UNITED STATES PATENT AND TRADEMARK OFFICE

Office Action Summary

10/630,342

DETAILED ACTION

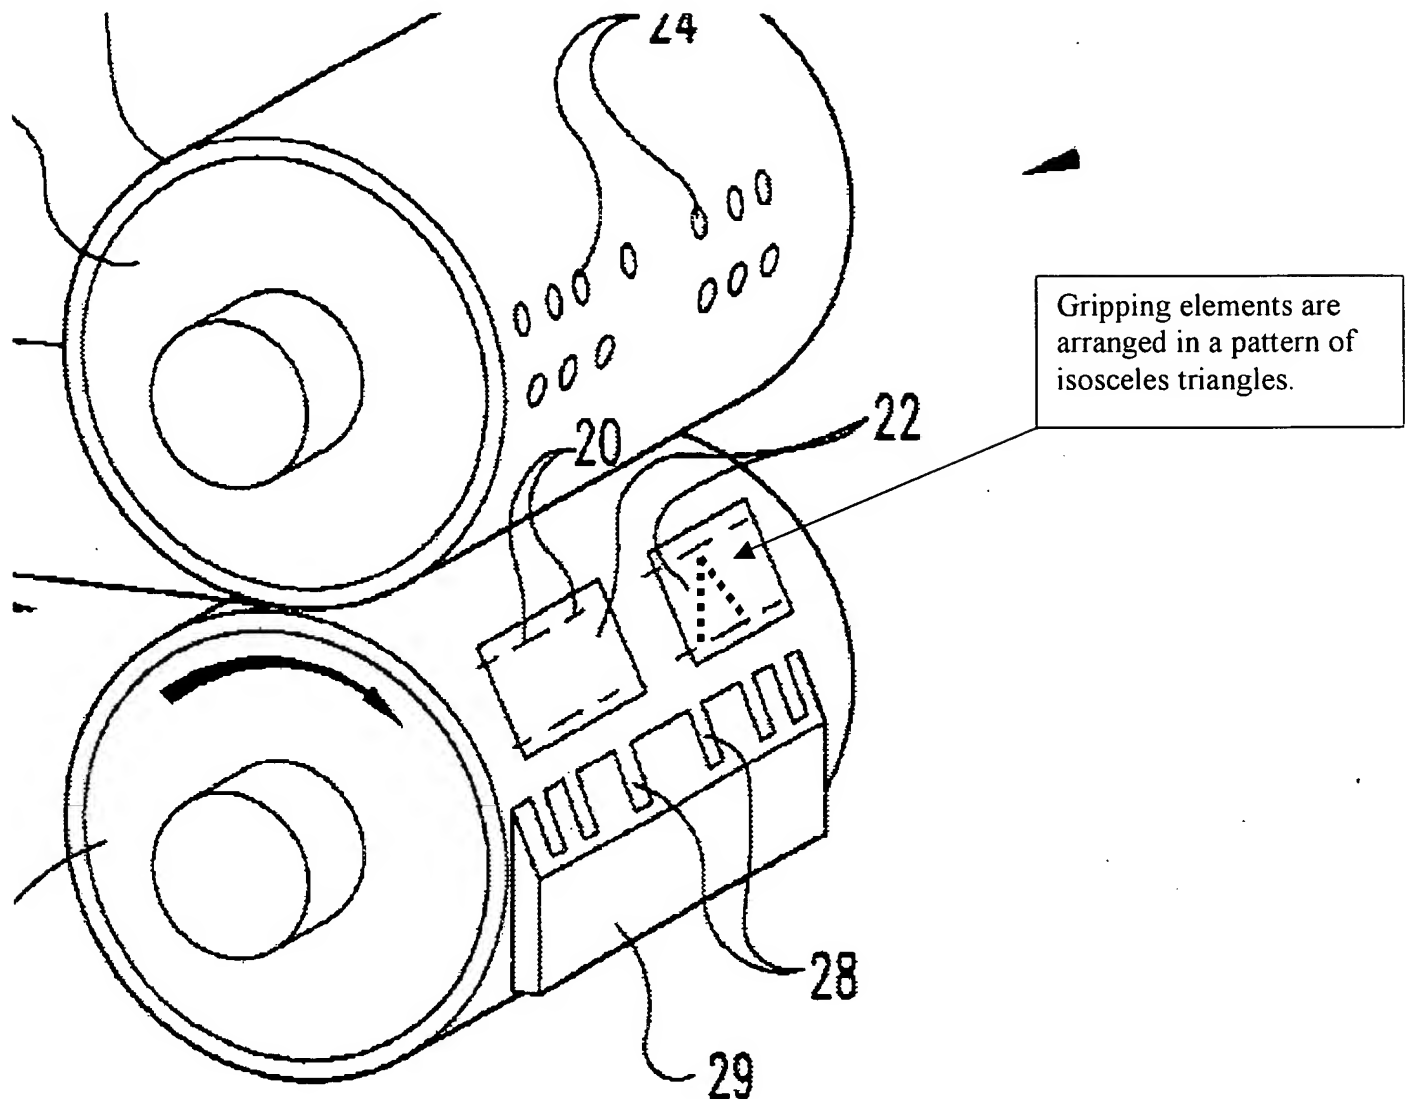
Regarding claim 38, the gripping elements are arranged in a pattern of isosceles triangles. See attached Fig. 1.

Elements 200 are at 3 points of an isosceles triangle

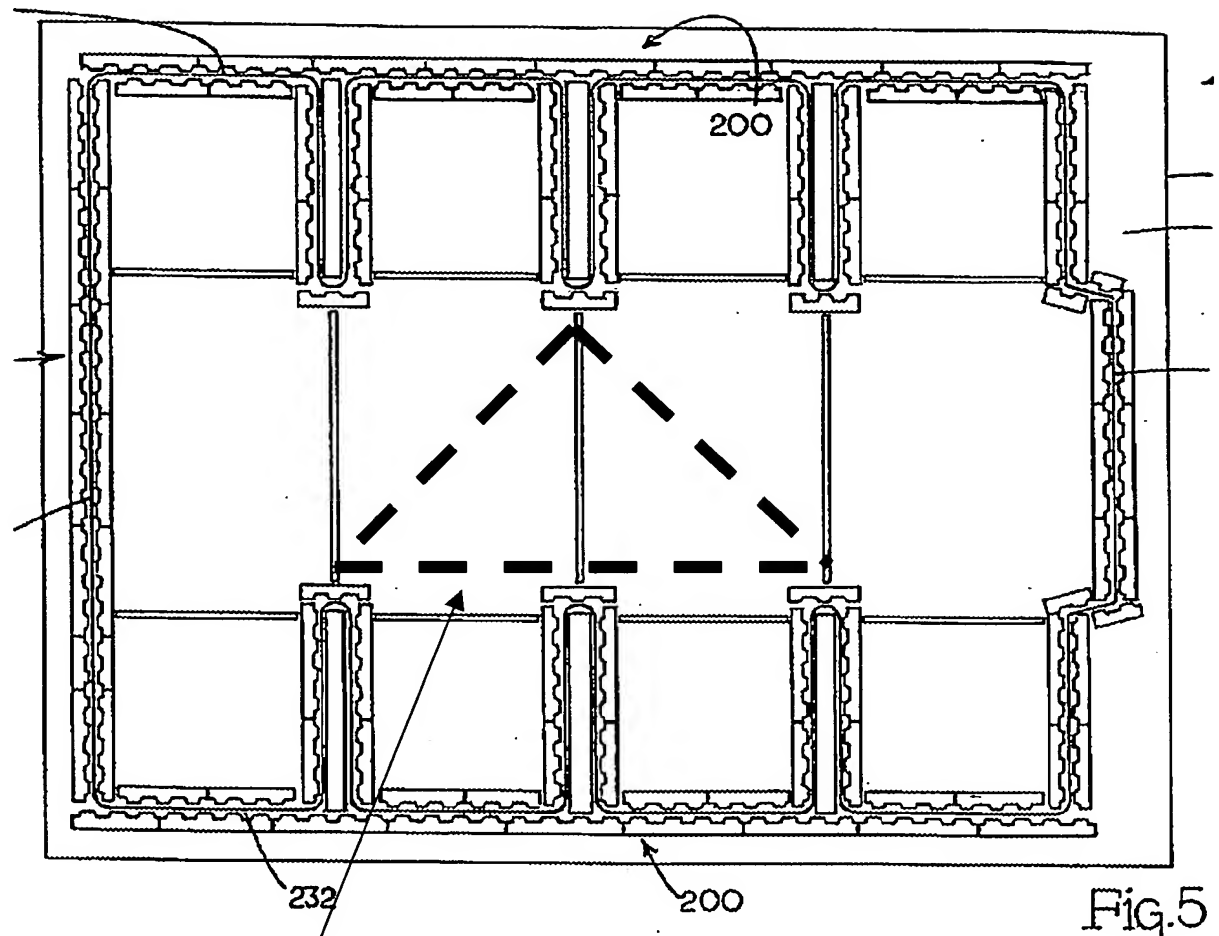
Regarding claims 31 and 32, Applicant asserts that Smithwick does not teach element 200 are at 3 points of an isosceles triangle. Applicant is directed to the attached Fig. 5 below.
